QUATRO CONSTRUCTION LLC

Date: 3/15/16

Re: Circle K Raise & Rebuild,
1420 W. Stadium Blvd
Ann Arbor MI

The following list is a basic list of the concerns presented by the neighboring properties to the Circle K project and a list of how they were addressed where possible.

↑ SITE LAYOUT PLAN—CIRCLE K OR SOMEONE ELSE COULD
 SCALE 1"=20'

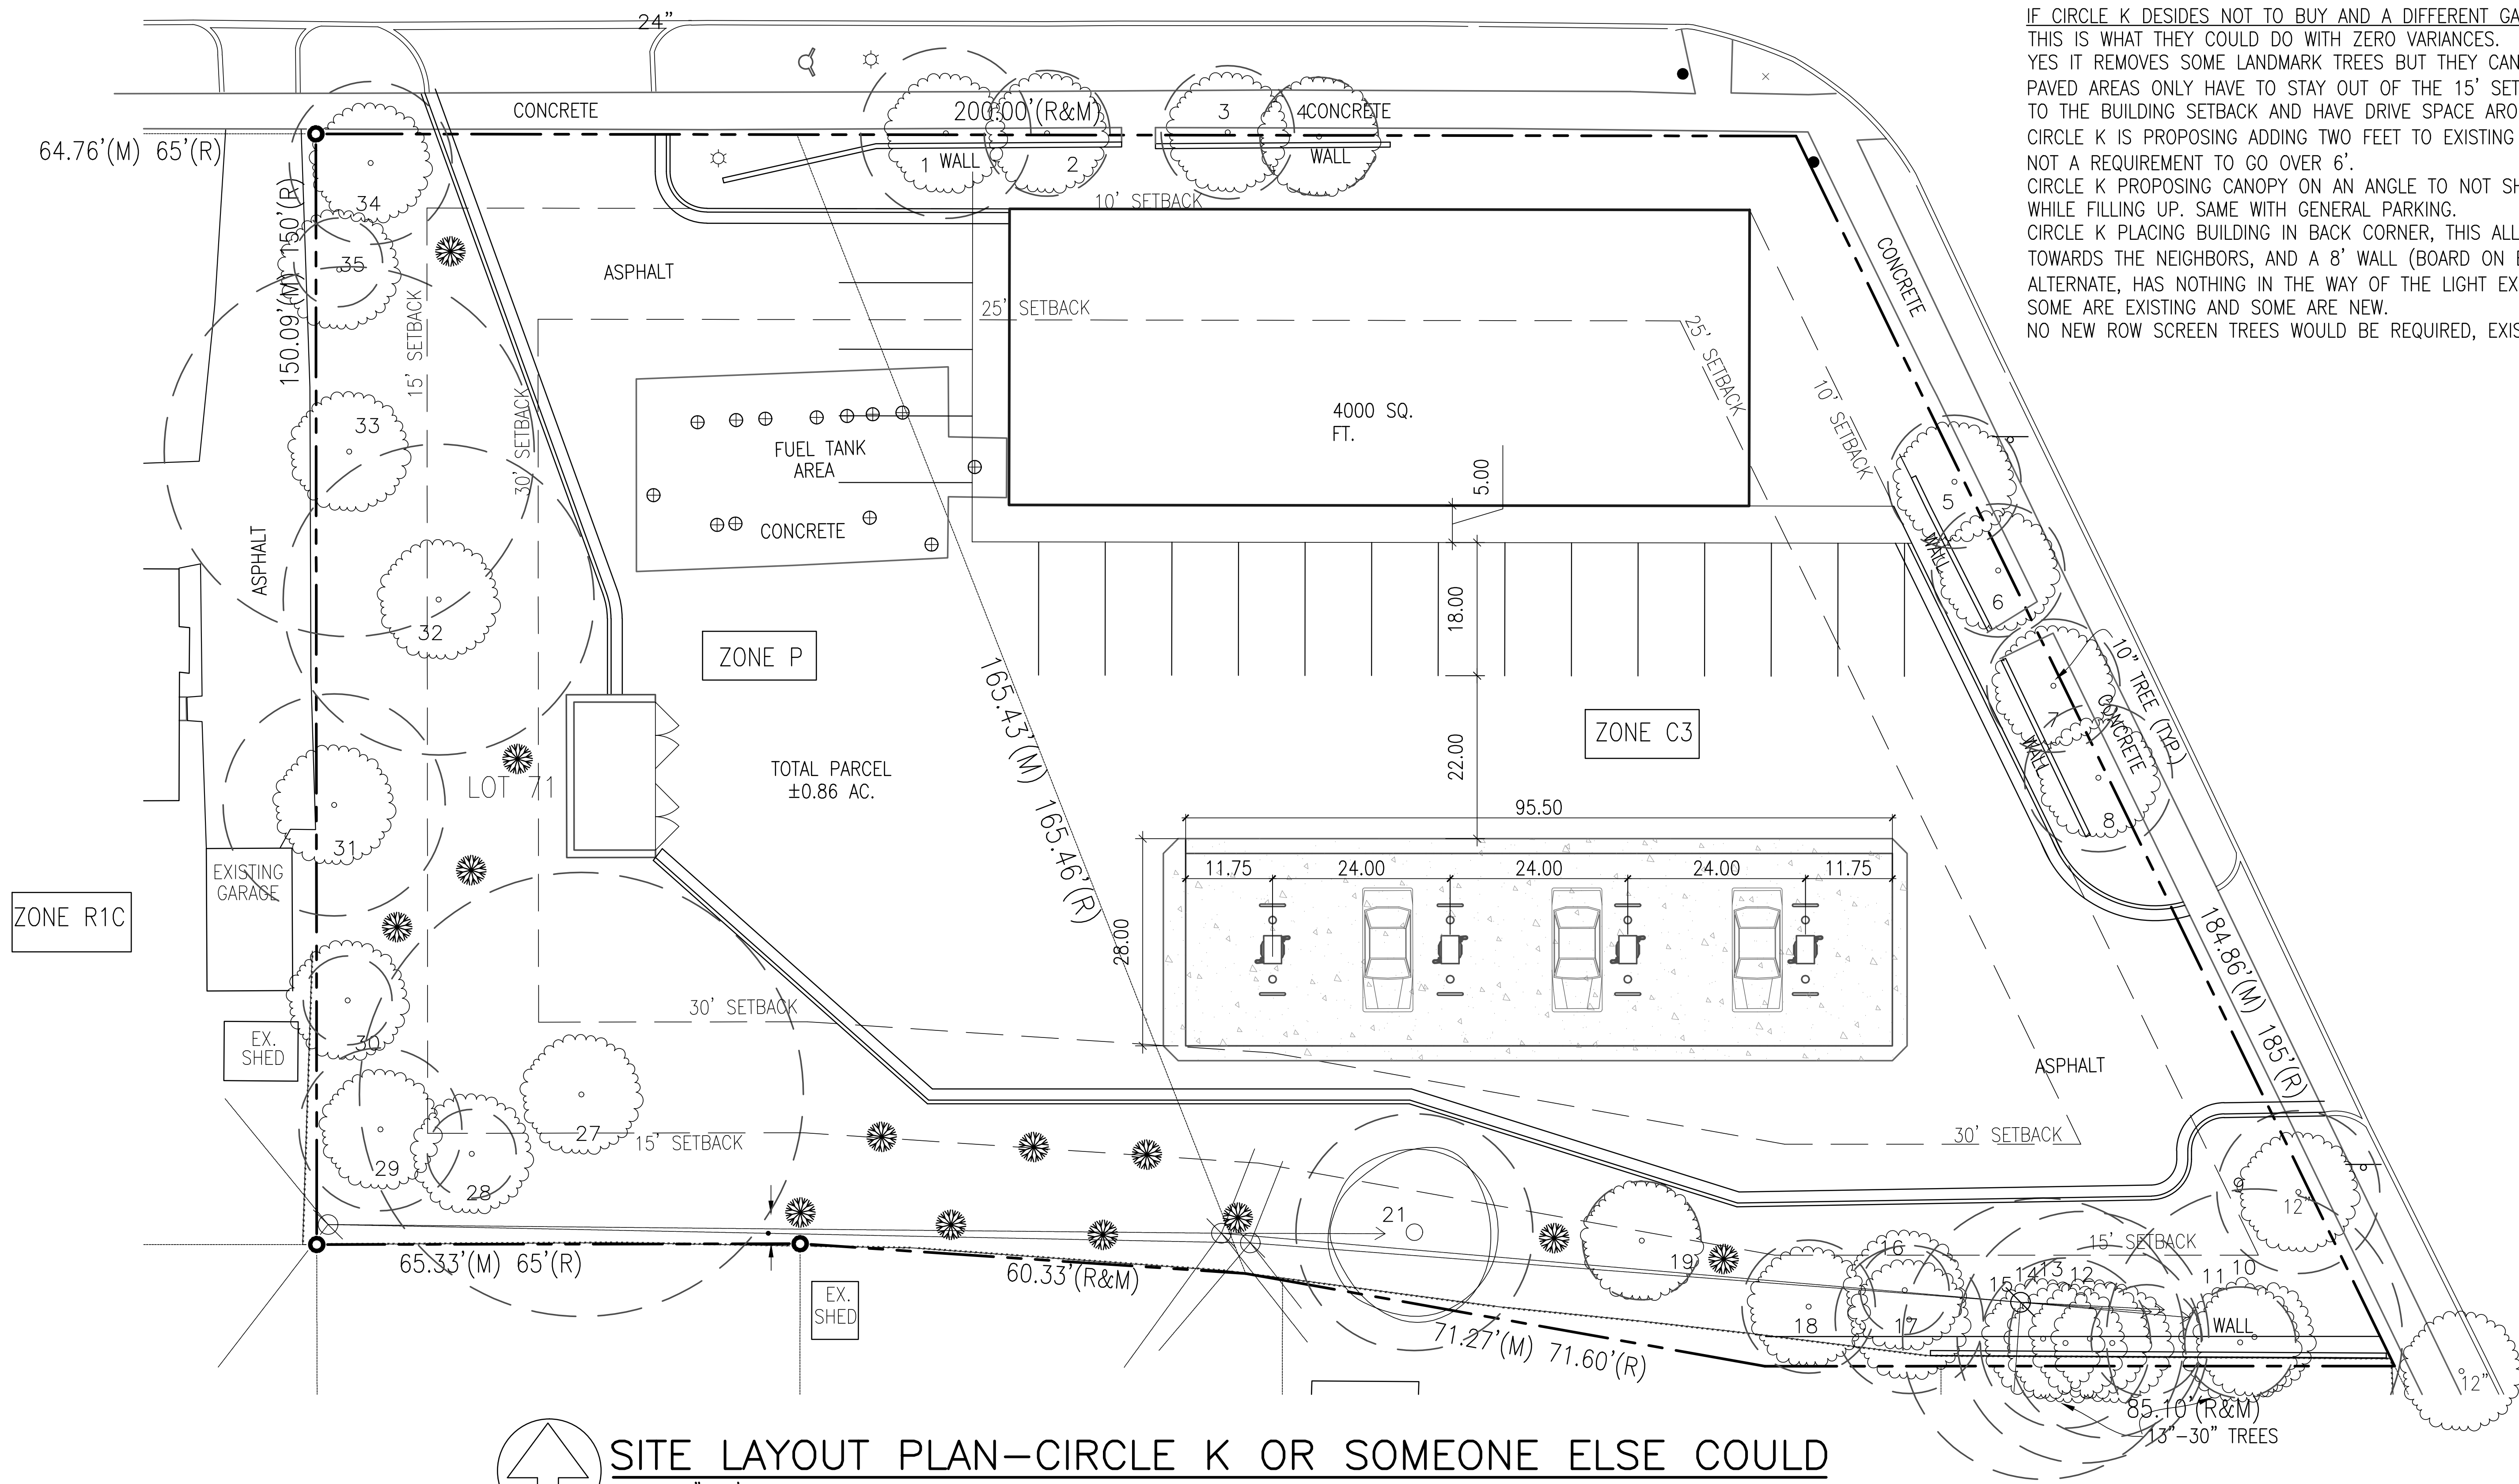
In addition I'd like to show an alternate that doesn't require any variances from the city. It is not what Circle K wants to do, but if we cannot move forward the plan as

currently proposed it is what someone else could do should Circle K decide to relocate elsewhere (where they would be able to do a store of standard size and shape) 4,000-5,000 sq. ft. and rectangular.

With this plan the building is up front on the corner and the canopy is in the back. It still allows for 8 pumps stations, double dumpster, 4000 sq. ft. building retail/convenience, 16 parking spaces (with ada space) aside from the pumping stations. Keeps many landmark trees, does require 1 mitigation tree. Would not be required to have a residential style (pitched) roof. Only would be required to screen HVAC (roof top units).

I feel this option is much less in line with the local community and is why we are pushing for the variances we are. But again it is perfectly legal with no Variances.
